SERVICE INFORMATION

Bulletin Nbr: 843-1587

Adapting door mirror for tall drivers

All Saab 900 M1994-

D843-B604

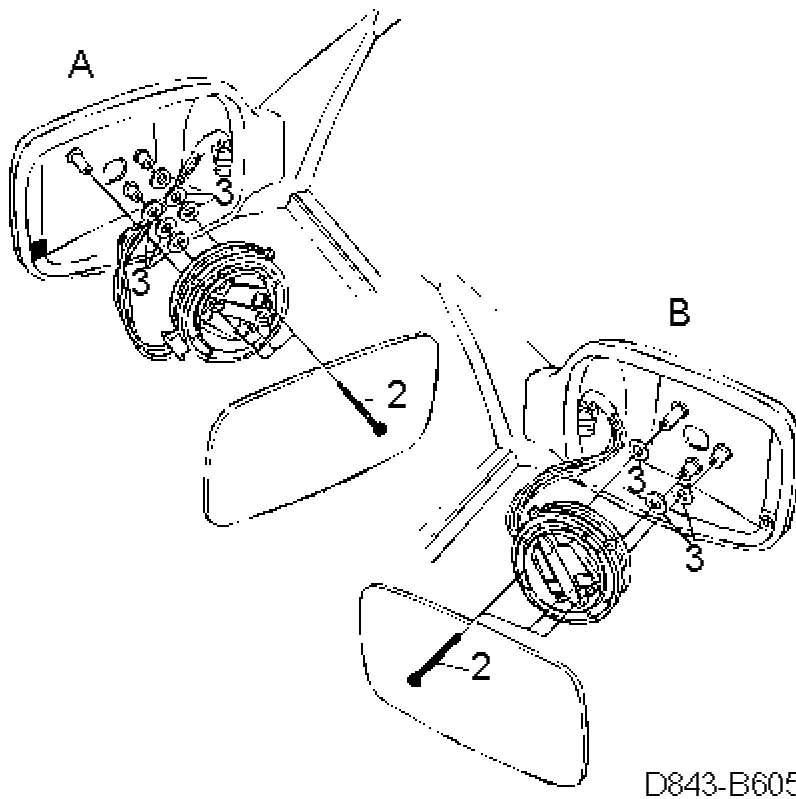
In some cases it has been found that the door mirror on the driver's side needs to be angled outwards by a greater amount in order to give tall drivers a more convenient rearward vision. In the event of customer complaints, the angle can be increased on LHD cars by adding washers to two of the mirror mechanism's three mounting points. On RHD cars a single washer should be added to all three mounting points.

Place 3 washers under two of the screws as shown in illustration A.

Place 1 washer under each screw as shown in illustration B.

Tighten the electric motor by first tightening the two screws with the washers. Do not overtighten. Then, tighten the last screw.

Tightening torque: 1.5 Nm (1.1 lbf ft)
